Customer:
KOCON LLC
2075 WALTON CREEK RD
STEAMBOAT SPRINGS, CO
BUILDING 2

Scale : 3/8" = 1'
Date: 8/21/2025
Building Code: IBC 2021
Drawn By: Henry Wolfe
Job Number: Q250434

KOCON LLC - Terrain at Walton Creek - Building #2

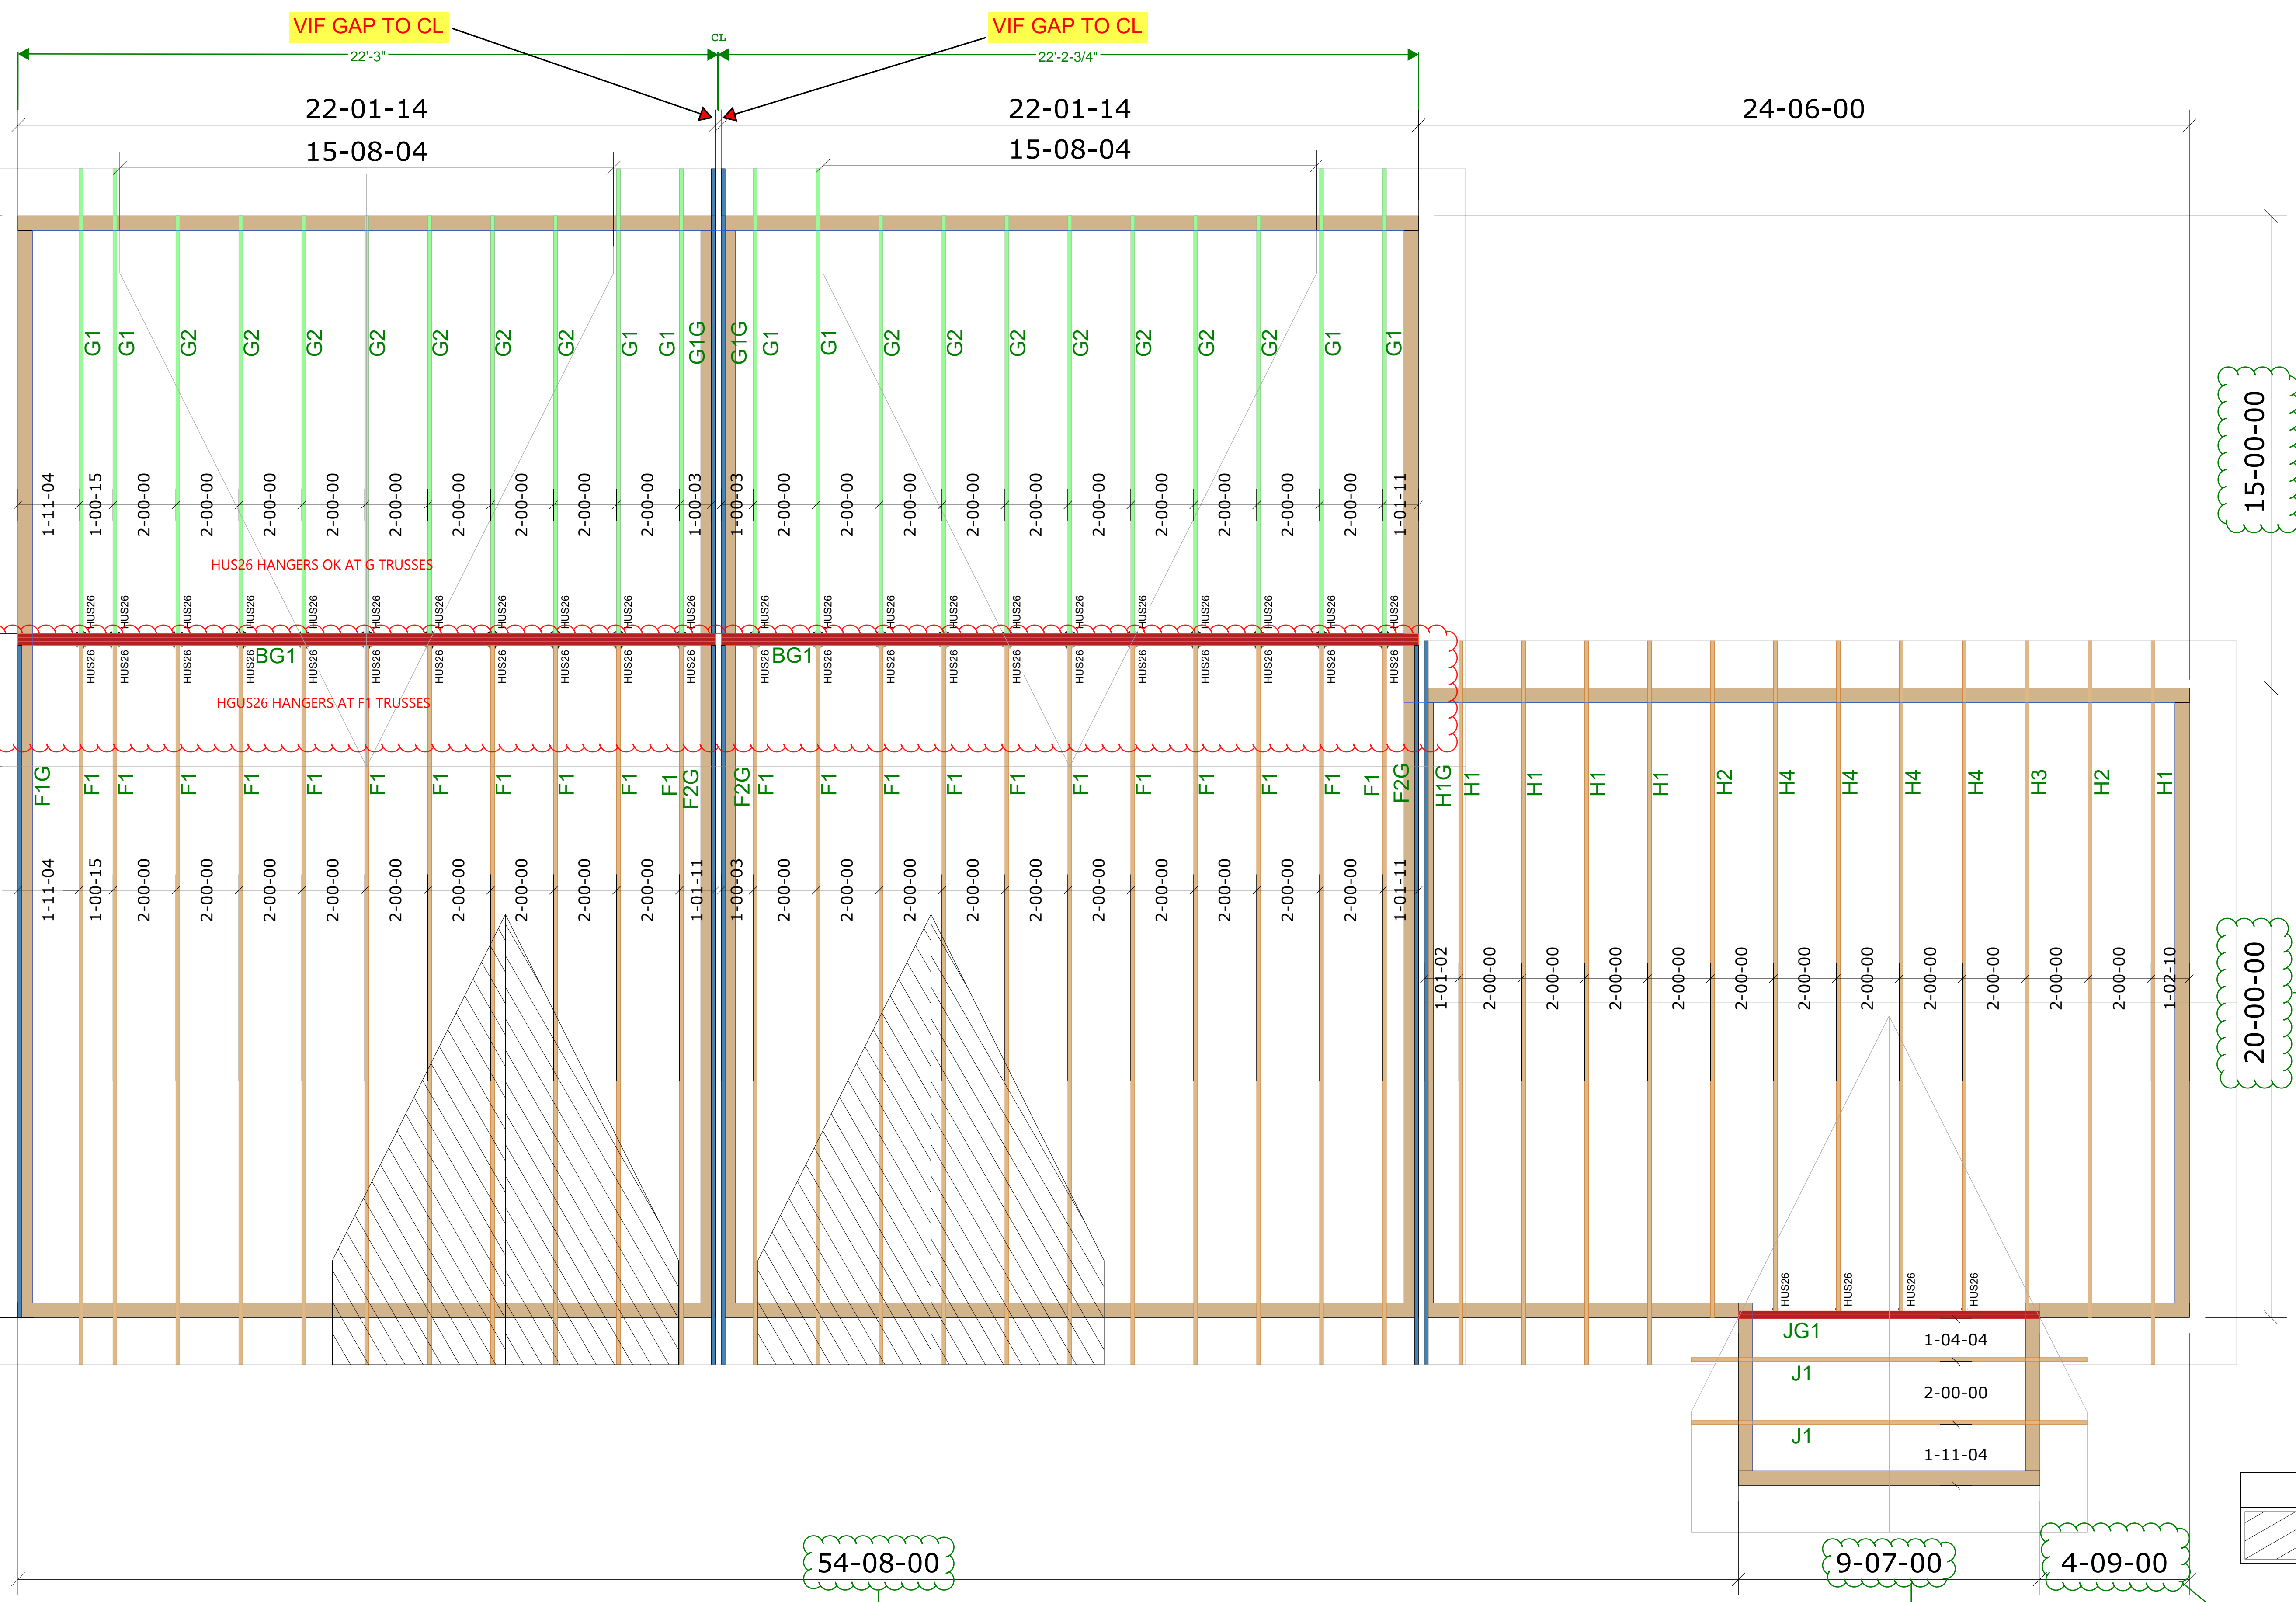
Actual dimensions have been field verified by KOCON. Arch/Structural Engineer to confirm clouded dimensions needed that are not shown on plans.

Arch/Engr Verify Scaled dimensions.
Notes for AOR/EOR:
- 34'-6" on Arch Dwgs

35'-0" CONFIRMED
Arch/Eng Verify these dimensions

Arch/Eng Verify.
14'-6" on Arch Dwgs
USE FIELD VERIFIED DIM. 15'-2"

Field Verified Actual: 20'-0"
20'-0" CONFIRMED

Field Verified Actual: 54'-8"
- 54'-8" on Structural
USE FIELD VERIFIED DIM: 54'-8"

Field Verified Actual: 9'-6 3/4"
Notes for AOR/EOR:
- 9'-7" on Structural
- 5'-3" on Structural
- 4'-11-3/4" on Architectural
USE FIELD VERIFIED DIM. 9'-6 3/4" + OVERHANG

Field Verified Actual: 4'-9"
Notes for AOR/EOR:
- 5'-3" on Structural
- 4'-11-3/4" on Architectural
USE FIELD VERIFIED DIM: 4'-9"
